Determination 2017/081

Regarding the compliance of a ground floor landing to a set of stairs in a residential unit at 21 Commercial Street, Takaka

Summary

Figure 1: ground floor plan from consent documentation (not to scale)

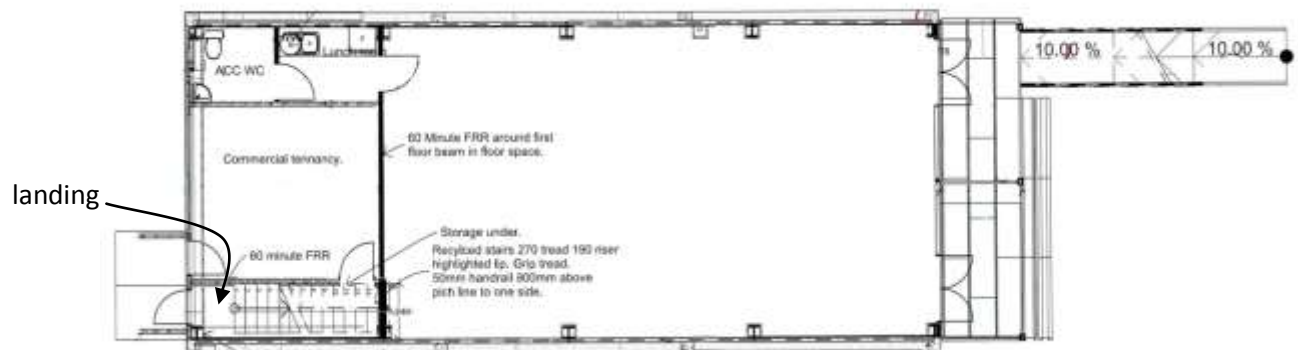
- 2.4 The plans submitted for building consent show a landing 1.24m wide and 1002mm long from the external door to the first riser. It was noted on the plans that the stairs were to be a recycled building element from a different building, with 270mm treads and 190mm risers.

- 2.6 The authority issued building consent No. 160056 on 28 April 2016 for the alterations. The building consent was subject to an amendment issued on 14 September 2016; the dimension of the ground floor landing in the approved plans⁶ is shown as 0.961mm.

- The alternative solution was agreed to on the basis of a 1,002mm long landing at the bottom of the stair ... For some reason this has not been achieved. A landing length of just 450mm (as measured on site) is a significant difference and therefore not ‘minor’ in nature.

- The as-built landing at 435mm does not comply with the building consent which had a dimension of 1002mm for the landing, nor does it comply with the Acceptable Solution D1/AS1 which would require 900mm.

- 4.2.11 In conclusion, I consider the area between the door and the first riser does not provide adequate activity space for a person to stand and operate the door and so does not comply with Clause D1.3.3(a).

- 5.1 In accordance with section 188 of the Building Act 2004, I hereby determine that the stair landing at the base of the stairs does not comply with Clause D1.3.3 of the Building Code.

Figure 2: sketch of clearance around door swing

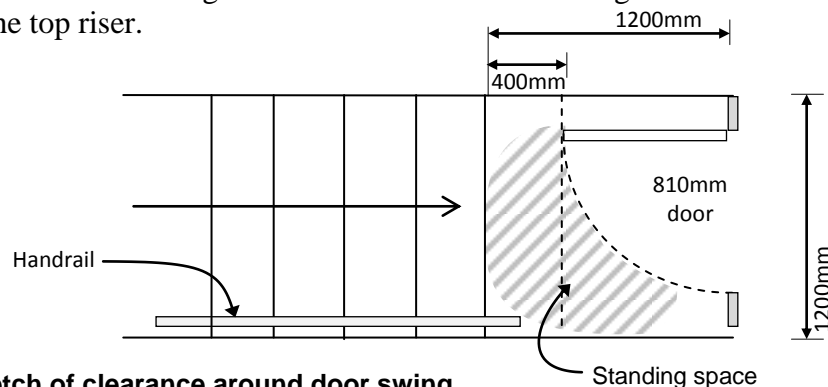
- 4.2.6 The designer has submitted that because a clear space of 400mm is acceptable under D1/AS1, where a door opens onto a landing (refer Appendix A.2), in comparison the as-built landing at 435mm provides adequate space to meet the requirements of Clause D1.

- 4.2.7 I disagree with the designer in this matter. I do not consider the clear space in D1/AS1 for a door swing onto a landing is relevant to the question of what is adequate for the landing considered in this determination. When opening a door that swings onto a landing, clear space is provided for the person to move around the door without needing to use the steps; as shown in the figure below there is a significant area of the landing still available outside the swing of the door that is well away from the top riser.
